SUBJECT: INSPECTION OF FUEL PRESSURE LINE

MODELS AFFECTED: M-20E S/N's: 101 thru 1308
670001 thru 670062
690001 thru 690073
700001 thru 700053

M-20F S/N's: 660003, 660004
670001 thru 670539
680001 thru 680206
690001 thru 690092
700001 thru 700057

View Looking Inbd.
on R.H. Engine Compartment

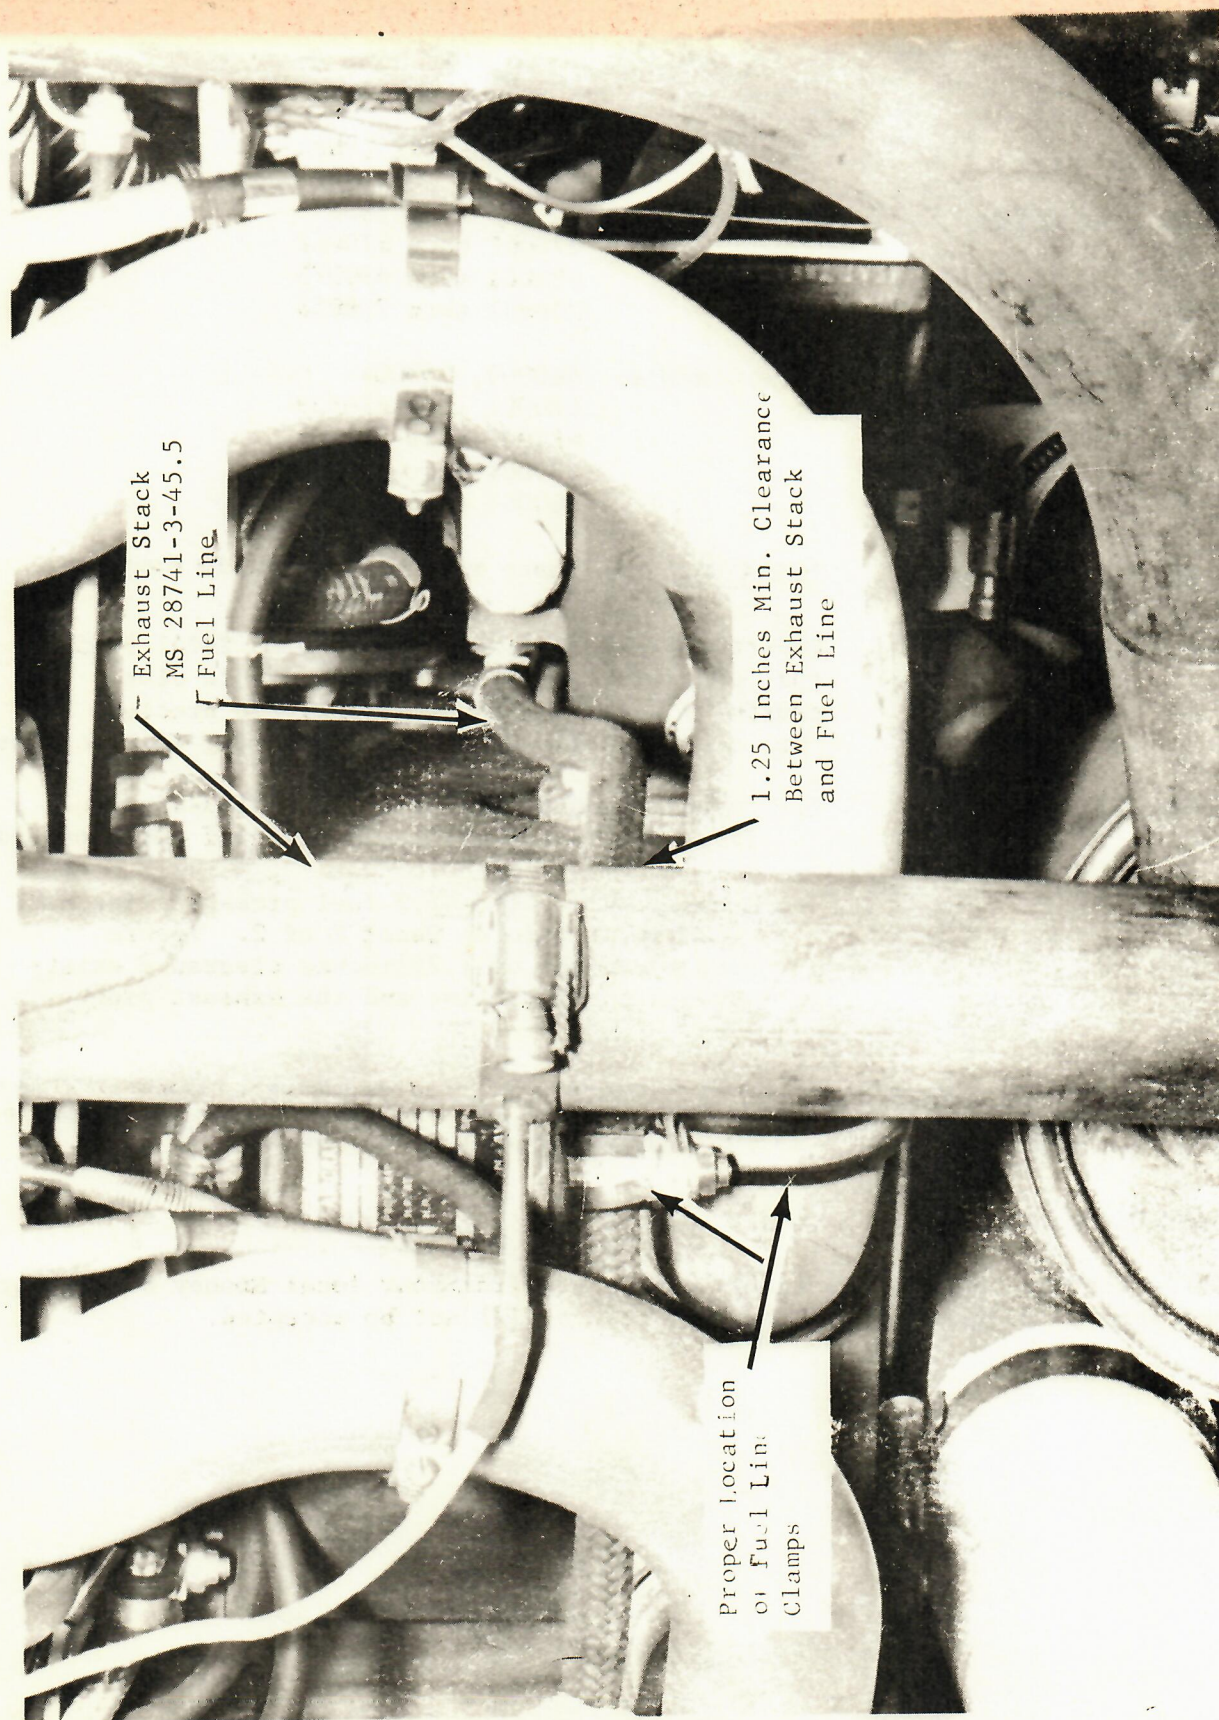
INTRODUCTION: Reports have been received of the MS 28741-3-45.5 fuel pressure line deteriorating due to close proximity with the exhaust stack. To preclude this condition accomplish the following instructions.

- INSTRUCTIONS:
1. Inspect condition of the MS 28741-3-45.5 fuel pressure line. Replace the line if deteriorated.
 2. Reroute MS 28741-3-45.5 fuel pressure line as shown in picture on Sheet 2 of 2. Insure that a minimum of 1.25 inches clearance exists between the fuel line and the exhaust pipe.
